TECHNICAL BULLETIN

* Supersedes Technical Bulletin TB900-009, dated 20 November 1998. Revised to reflect the correct part number for the Rod, Continuous Thread and other typographical errors. Aircraft that are in compliance with TB900-009 meet the intent of this revision.

MODIFICATION INSTRUCTIONS FOR 27 AMPERE HOUR BATTERY OPTION

MD900 helicopters, serial number 900-000002 thru 900-000062.

Table 1.

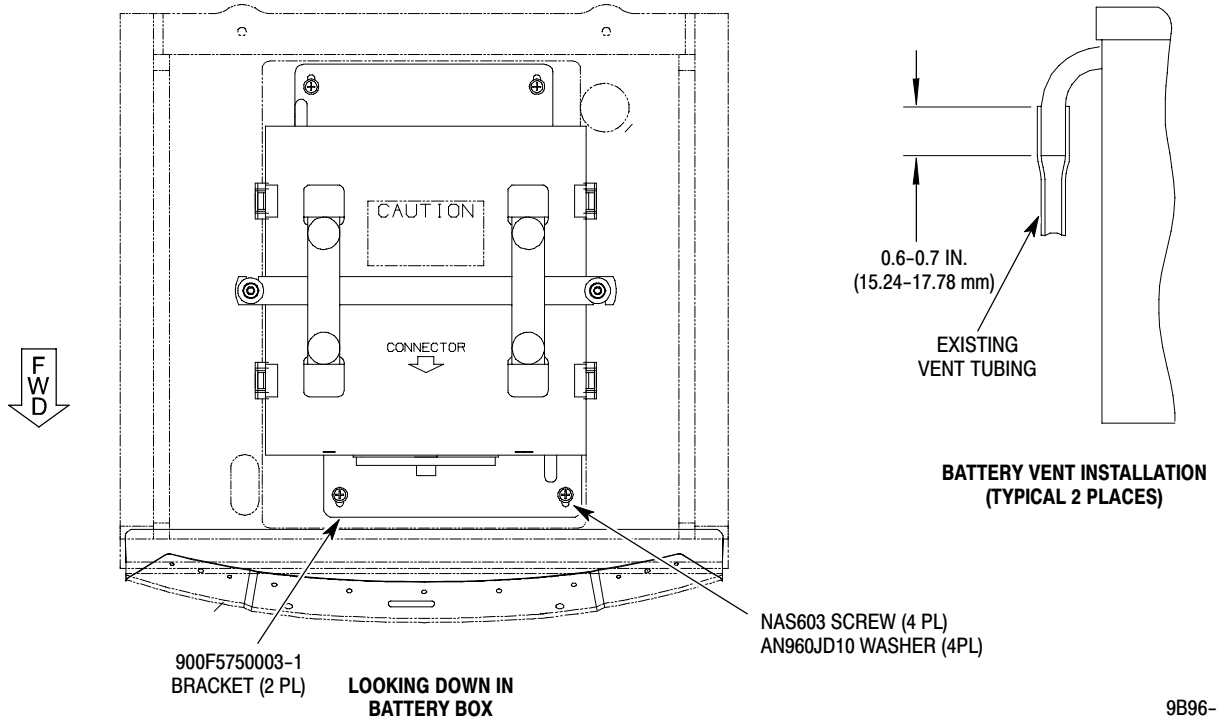
- (1). Remove existing aircraft battery and 2 ea. continuous threaded rod. Retain nuts and washers for reinstallation.
- (2). Install longer threaded rod into existing inserts a minimum of 0.280 in (7.11 mm). Torque only to overcome self locking run on torque.
- (3). Install aft battery bracket using NAS603 screws and AN960JD10 washers. Torque screws (Ref. CSP-SPM).
- (4). Install 27 ampere hour battery against aft bracket.
- (5). Install forward bracket and position to prevent fore and aft motion of battery. Torque screws (Ref. CSP-SPM).

- (6). Install previously removed washers and nuts onto threaded rod and tighten sufficiently to ensure no axial movement of the joint.
- (7). Install existing vent tubing onto battery case.
- (8). Record accomplishment of this Modification Instruction in the Compliance Record Section of the Helicopter Log Book.
